W5J9LE-12-R-0019

SOF Helicopter Apron Project, Herat

AMENDMENT NUMBER 1

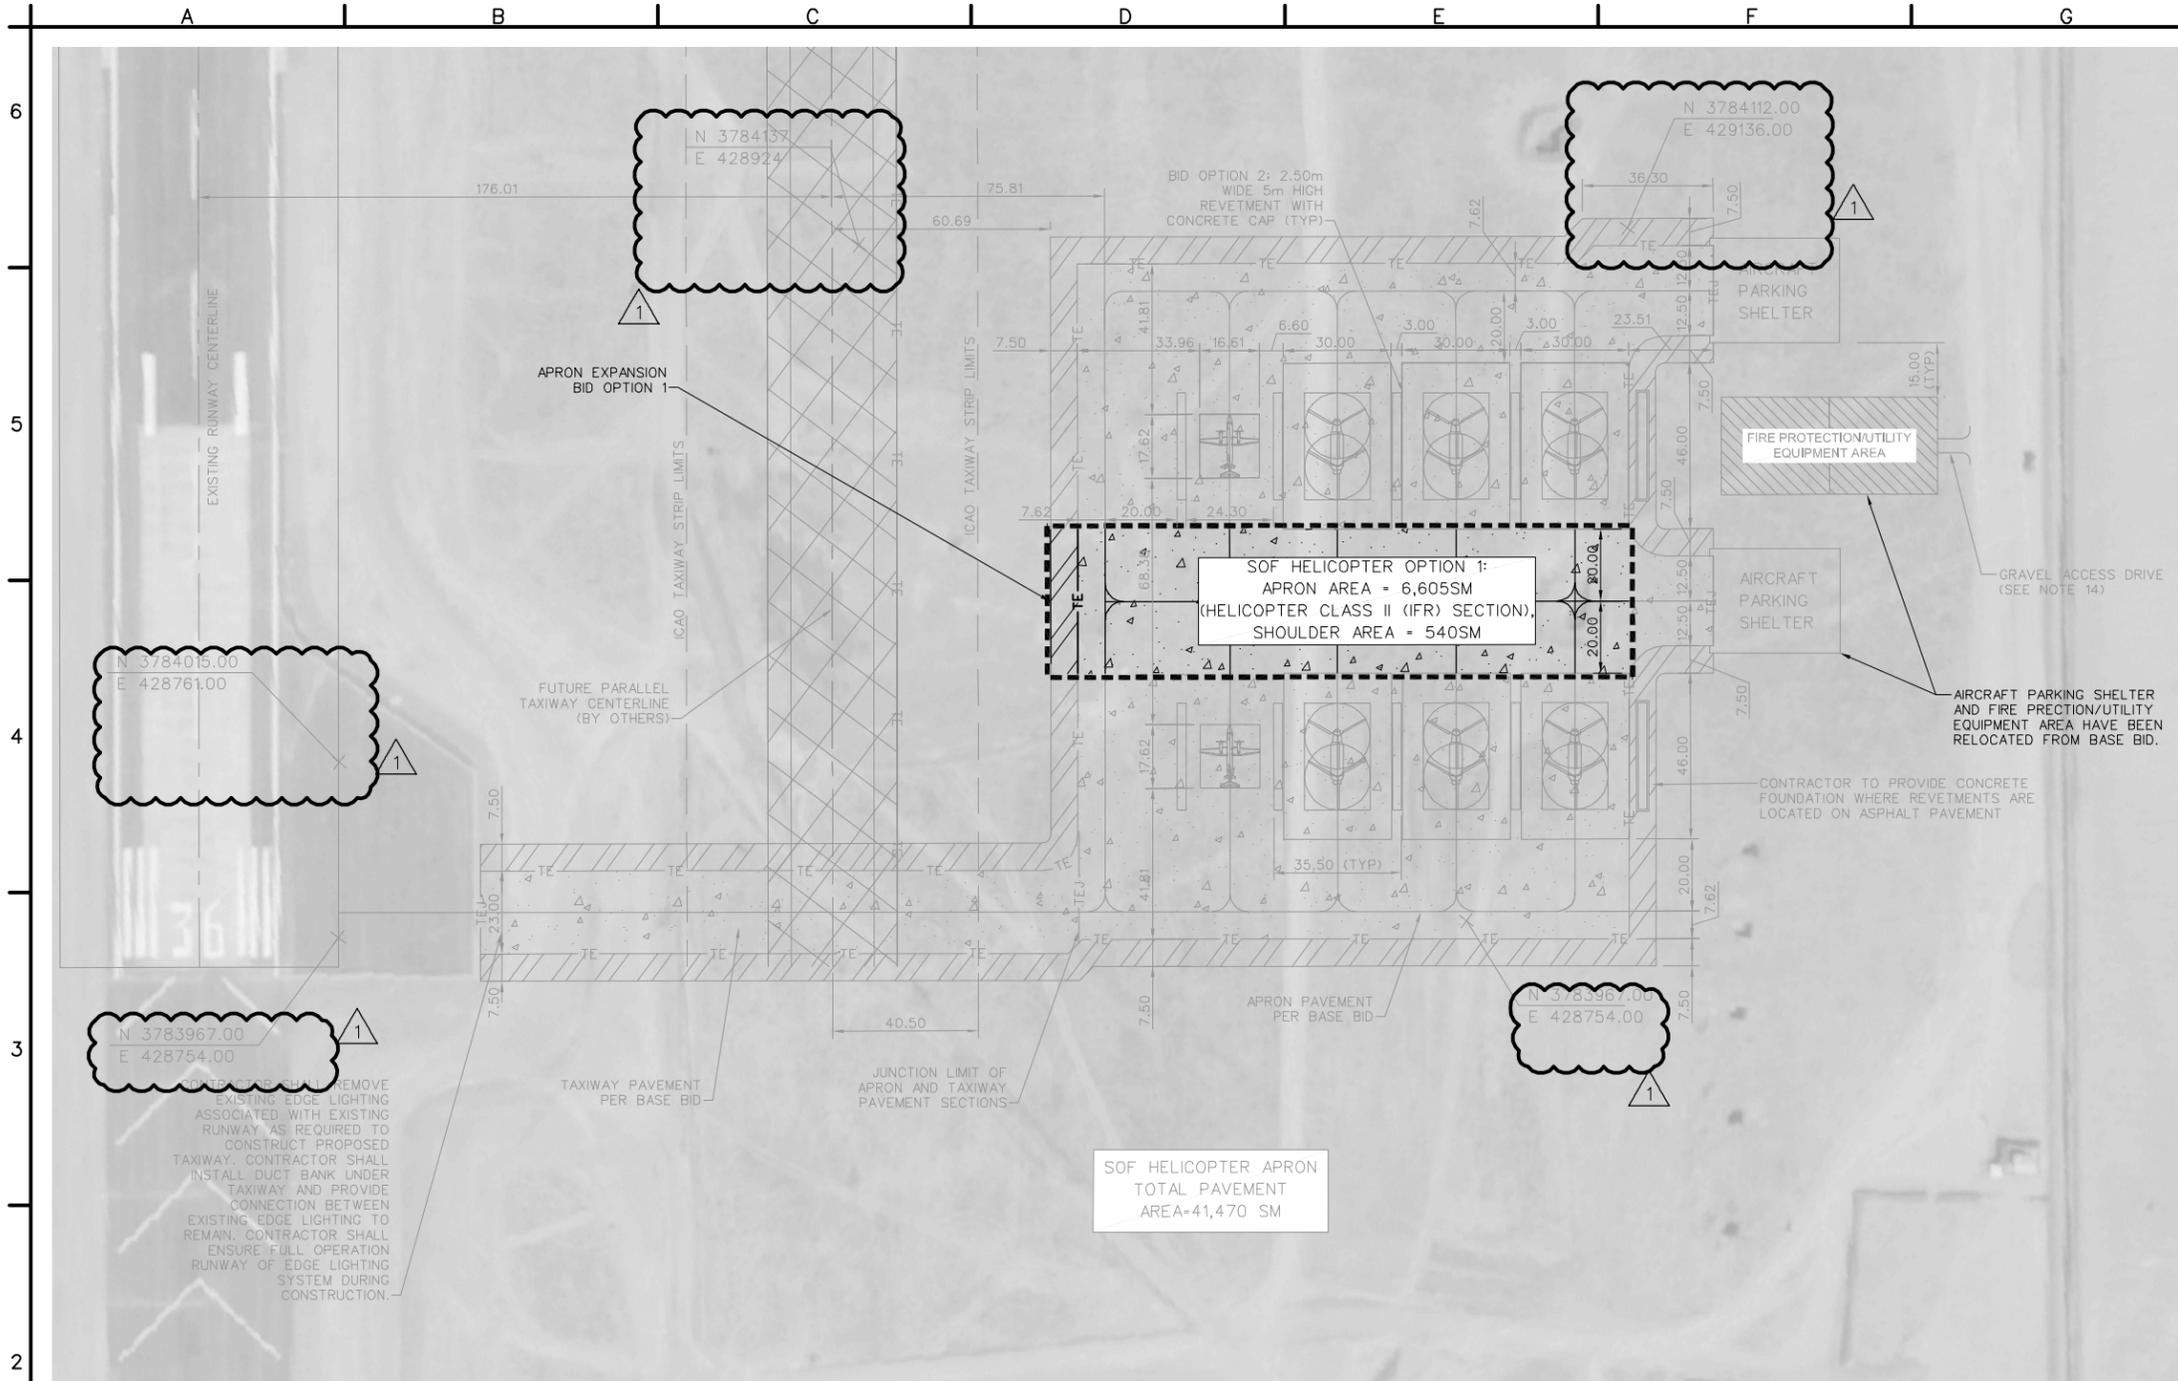
Q1. In Section 00113 Para 2, it is mentioned that the contractor will design and build 45,000 SM paved apron for rotary-wing and fixed wing aircraft. But it is indicated that the total pavement area is 41,470 SM in Drawing C-111 Site Plan. Could you please clarify this contradiction?

Q11- In Section 00010 Proposal Schedule, it is mentioned that the additional 6,065 SM paved apron are constructed for Optional Item #1 by the contractor. But it is indicated that the apron area (SOF Helicopter Option #1) is 6,605 SM in Drawing C-111 Site Plan. Could you please clarify this contradiction.

A1. Contractor pricing and technical proposals should be based on dimensions shown in the drawings already provided in the RFP. This amendment revises Section 0013 Para 2 to read “contractor will design and build a paved apron not to exceed 45,000 SM.”

A11- Both revised bid schedules and drawings indicate this work is under Option 1, Contractor to provide cost as indicated in the proposal schedule.
